JRC questions to SIGTP-02-22

*3rd SIG TP meeting, March 12-14, 2024
Aachen, Germany*

Smoke Assessment

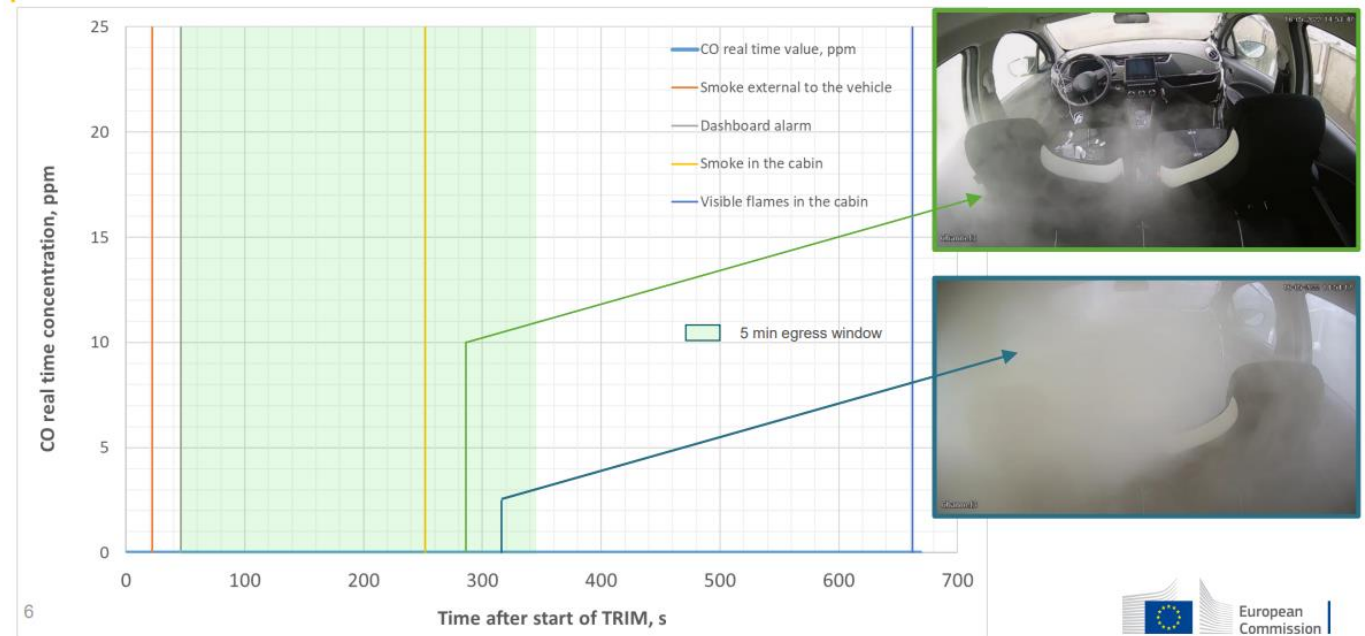
Is the smoke assessment related to whether the battery pack is inside or outside the passenger compartment ?

How are “inside the passenger compartment” and “outside the passenger compartment” defined?

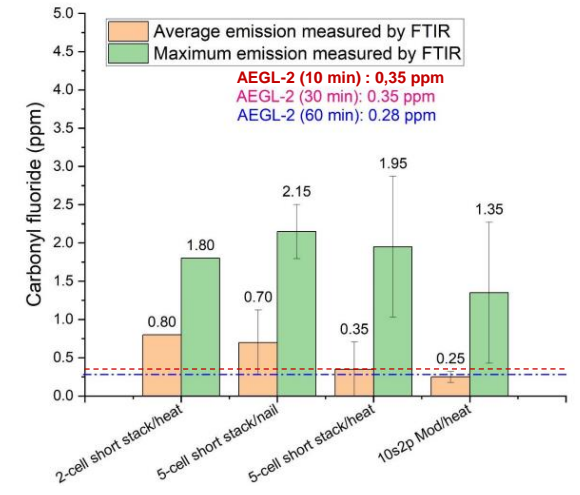
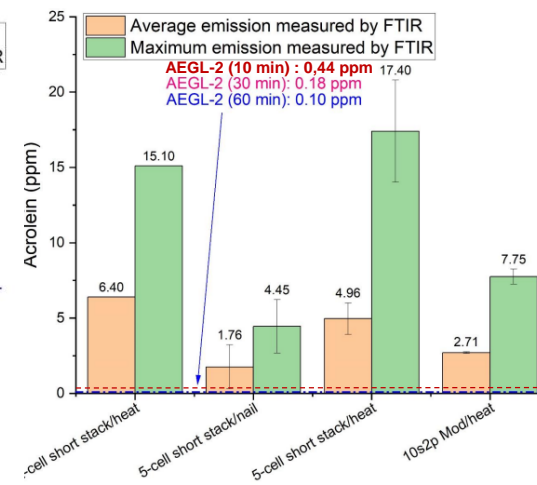
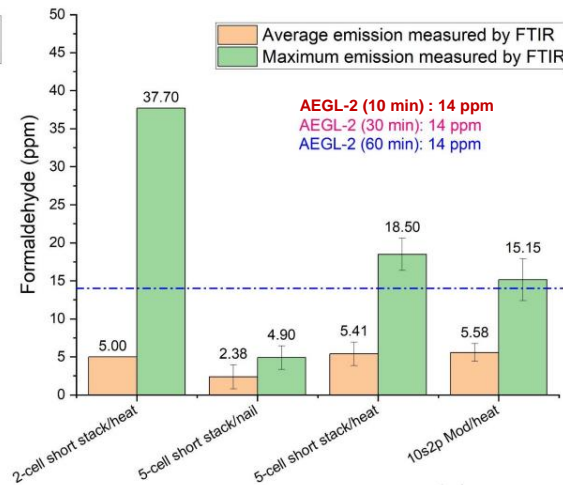
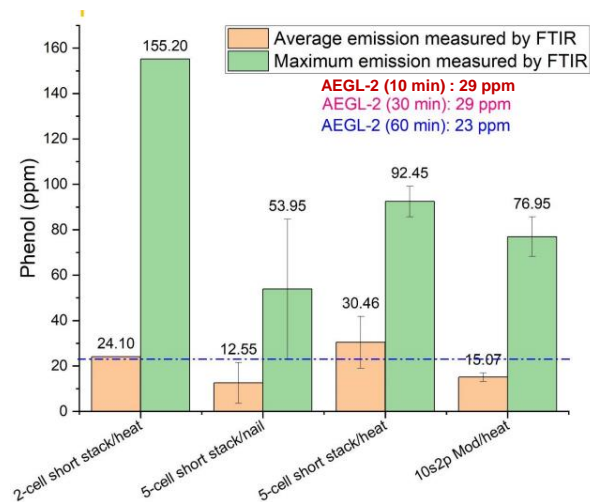
Thermal runaway (TR) and propagation experiments on 2-cell, 5-cell short stacks and 10s2p modules
 Hazards coming from **other smoke components such as: phenol, formaldehyde, acrolein and carbonyl fluoride** are almost always above AEGL-2 (10 min) exposure limits, where irreversible effects to human health are expected.

Reminder, AEGL-2 level indicates: “irreversible or other serious, long-lasting adverse health effects or an impaired ability to escape”

Smoke Assessment Procedure

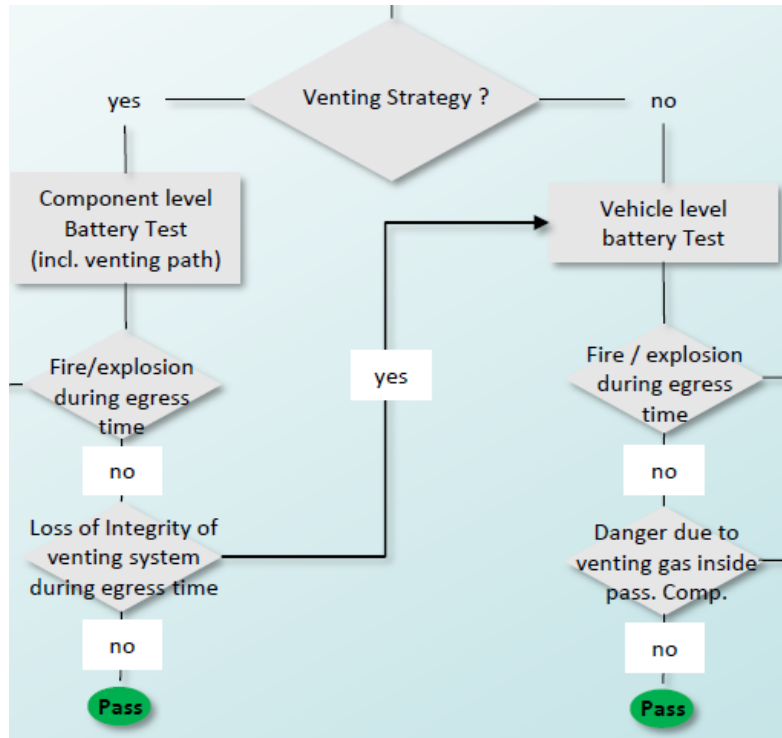
“Loss of integrity of venting system during egress time”

What is meant here? Is venting considered a “loss of integrity”?

How is *“danger due to venting gas inside pass.comp.”* evaluated?

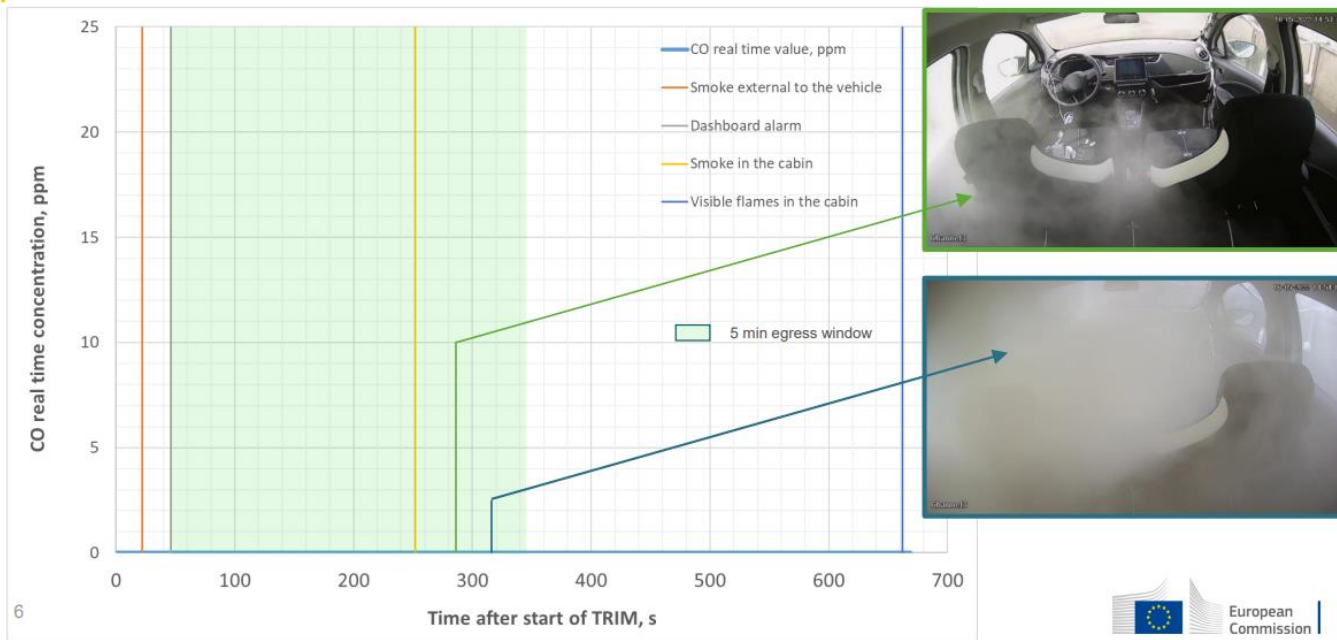
As previously mentioned, smoke assessment serves as a critical pass-fail criterion, as demonstrated in the previous study [EVS25-E2TG-0400 \[EC\]](#), smoke evaluation can occur within the stipulated time of 5 min, in Car A described in [EVS25-E2TG-0400 \[EC\]](#) visible smoke observed inside the cabin at 293 seconds.
